8 December 2021

PC210081 (PC81): Private Plan Change Request to the Operative Selwyn District Plan from Rolleston Industrial Developments Limited in Rolleston (Dunns Crossing Road) – Request for further information

Figure 1 Indicative realignment of Goulds Road being progressed via PC70

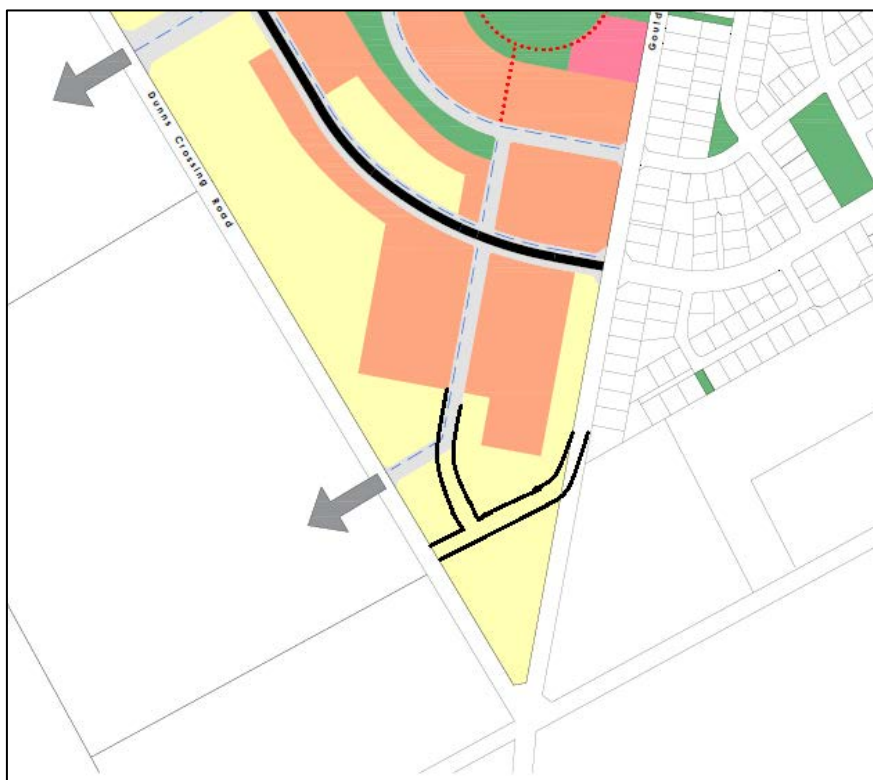
- x. The ITA identifies three main access points to this plan change request – two on Dunns Crossing Road and one on Selwyn Road. The ITA states that the design of these intersections will be confirmed during the subdivision stage. However, the southern access onto Dunns Crossing Road will likely form a key intersection with the future realignment of Goulds Road (currently being discussed between Council and PC70) as represented in the Rolleston Paramics model (and shown in Figures 12 and 13 of the ITA), and indicatively sketched in the figure below.
